SITE PLAN & ARCHITECTURAL COMMISSION AGENDA OCTOBER 16, 2020

Project Creekside Village
Applicant: Windy Creek, LLC; Agent: Joe Slaughter Consulting

File no. AC-20-205

Project Ritchie Trucking
Applicant and Agent: JB Steel, Inc.

EXHIBIT C-1

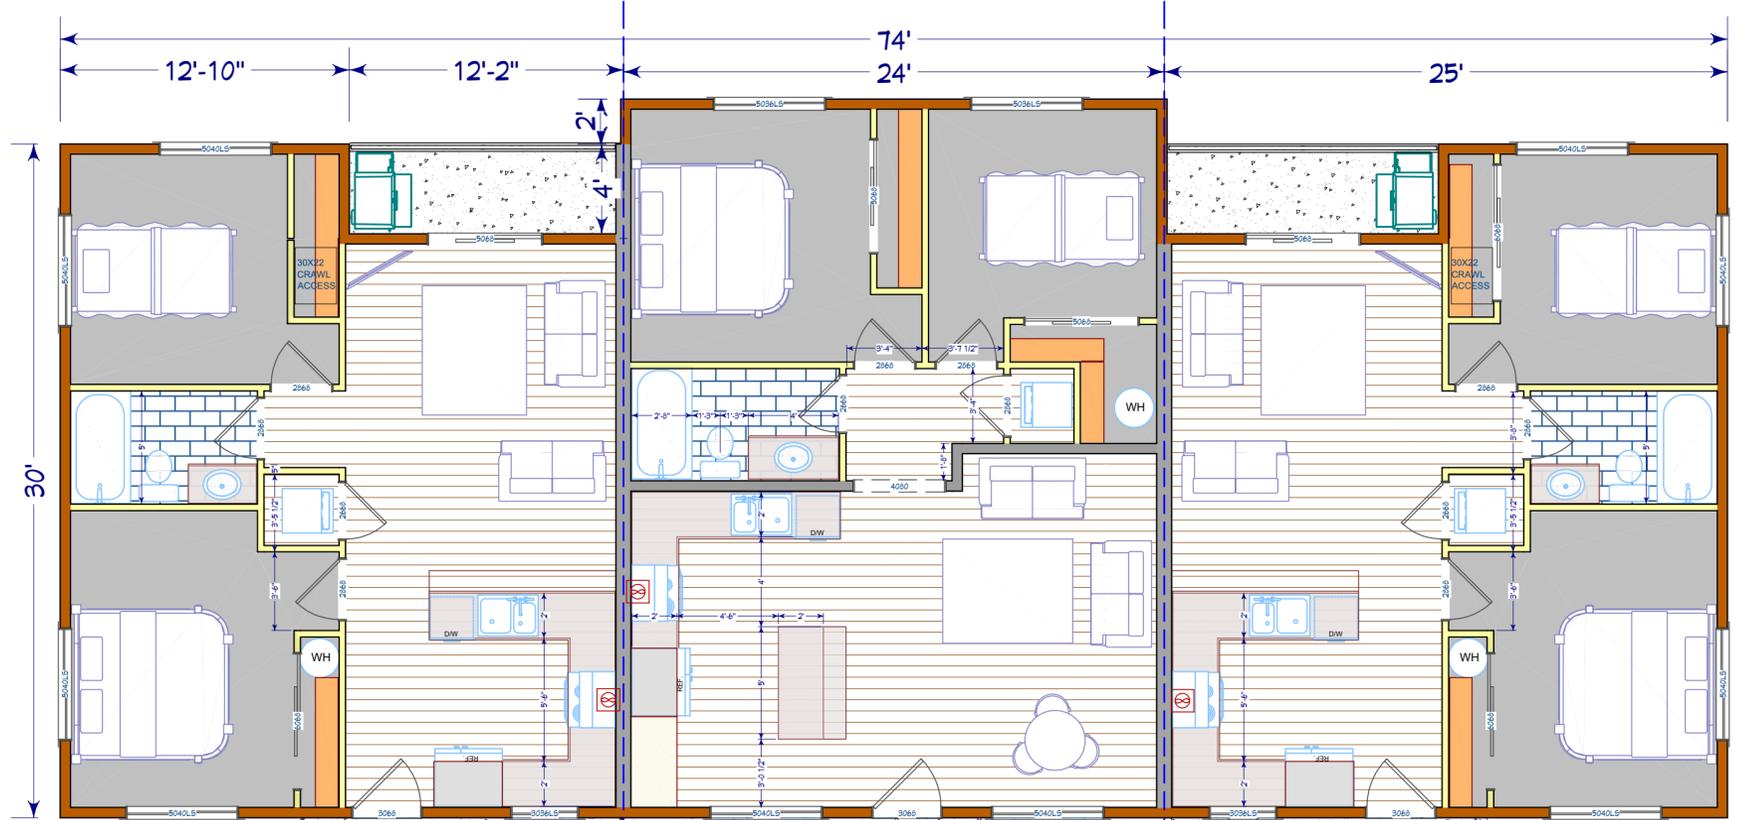
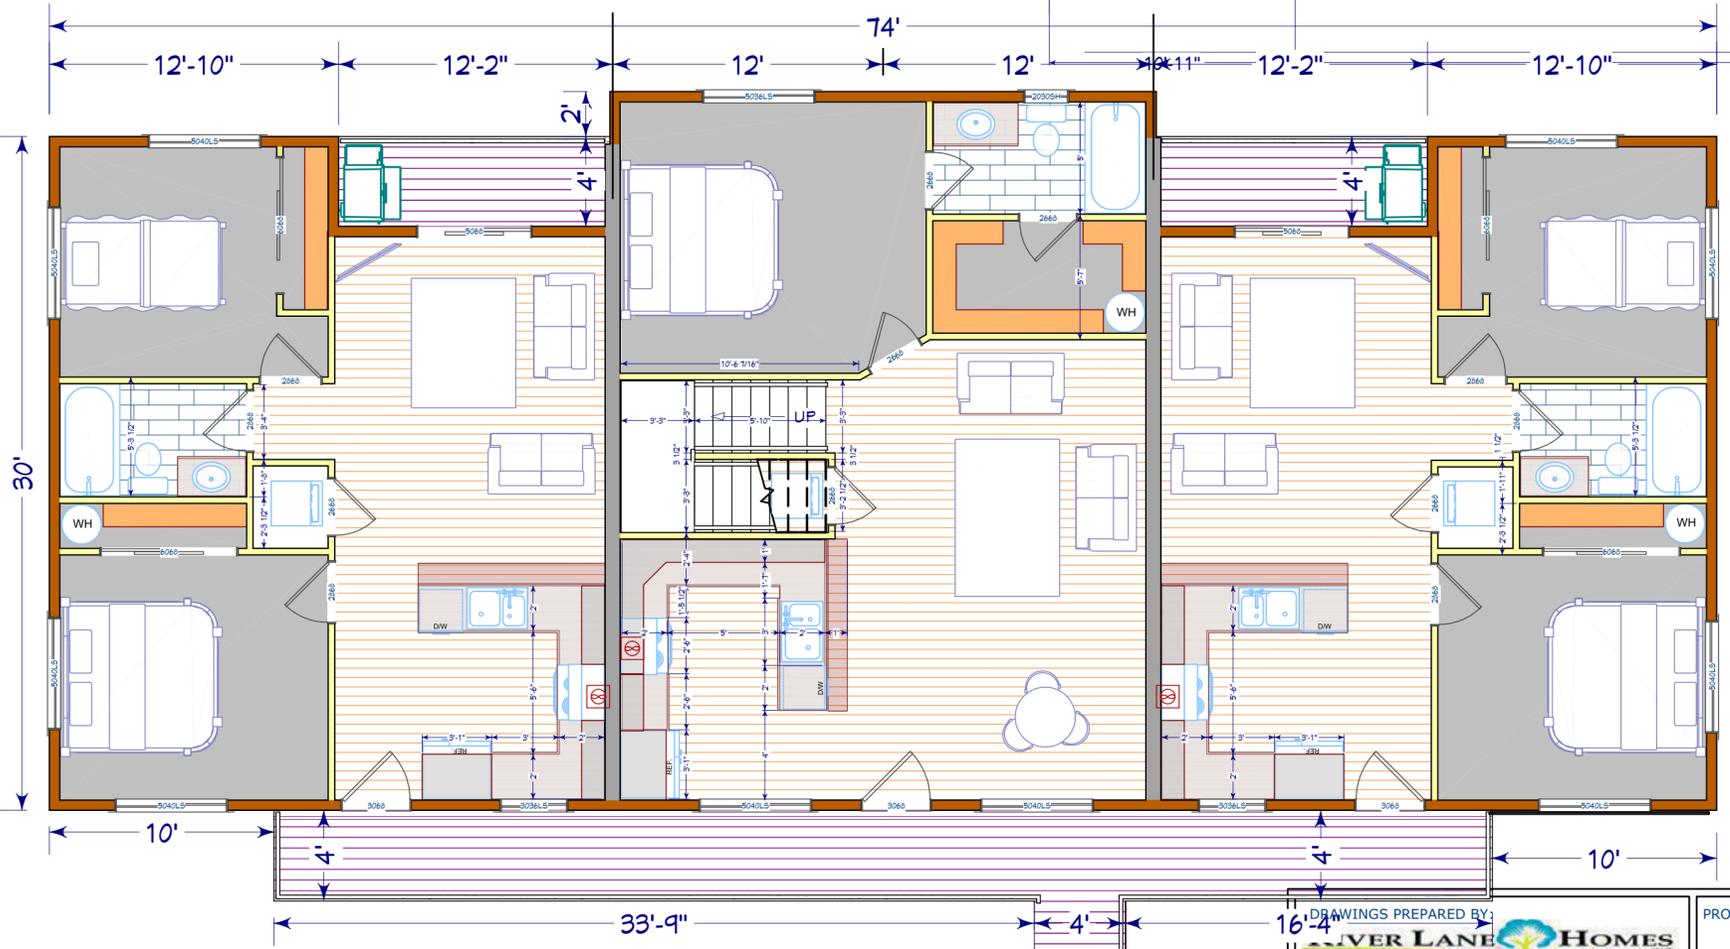
At the public hearing held on October 2, 2020, the Commission voted unanimously to approve the request. During the hearing, staff added two new exhibits into the record: A revised Floor Plan, included as Exhibit C-1; and a revised Elevation Plan, included as Exhibit D-1. The two revised plans were submitted by the applicant in response to a condition of approval requiring that the plans show windows on the third floor of the buildings, as required per the Special Development standards for multi-family buildings. As the revised plans satisfied the condition, the Commission struck the condition.

The two new exhibits (Exhibits C-1 & D-1) and the revised Conditions of Approval (Exhibit A-2) are included in this Commission Report.

1 SITE PLAN
1" = 20'-0"

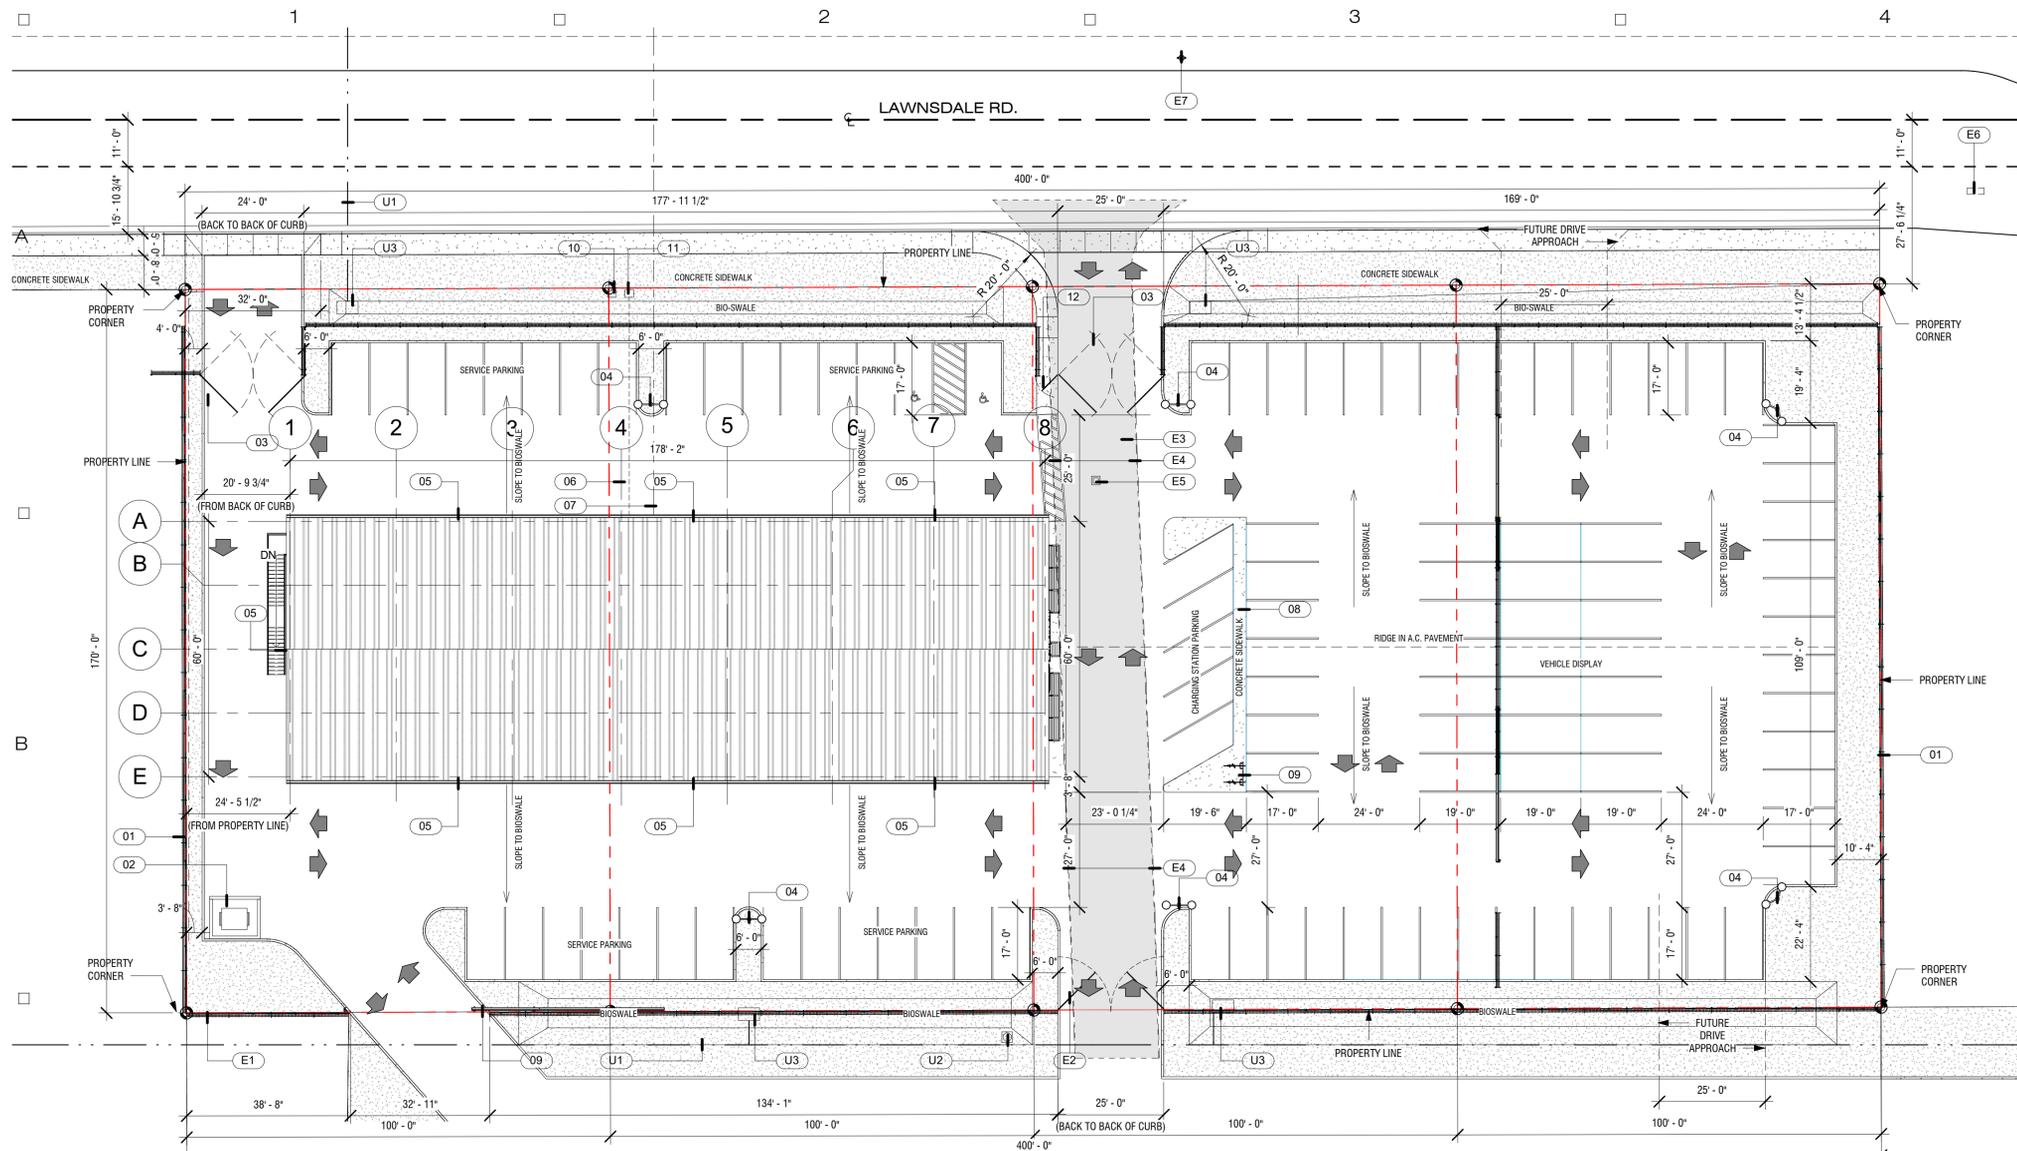
The applicant's site plan shows a curb-tight sidewalk with plantings located behind the sidewalk. In their submitted findings, the applicant argues that the proposed arrangement continues the pattern established in the surrounding neighborhood. The applicant has formally request relief, pursuant to MLDC 10.501(A), cited above, in order to install a curb-tight sidewalk along the site's frontage with Lawnsdale Road, as shown on their site plan.

Staff is unsupportive of the request. Planter strips move pedestrians a safe distance from the edge of the roadway, and Lawnsdale Road will be the primary route for pedestrians traveling to and from this development.

As a condition of approval, the applicant will be required to submit a revised site plan showing street improvements—including the installation of an eight-foot planter strip—along the site’s frontage with Lawnsdale Road, consistent with the requirements outlined in MLDC 10.429.

7. Submit a revised site plan showing street improvements—including the installation of an eight-foot planter strip—along the site’s frontage with Lawnsdale Road, consistent with the requirements outlined in MLDC 10.429.
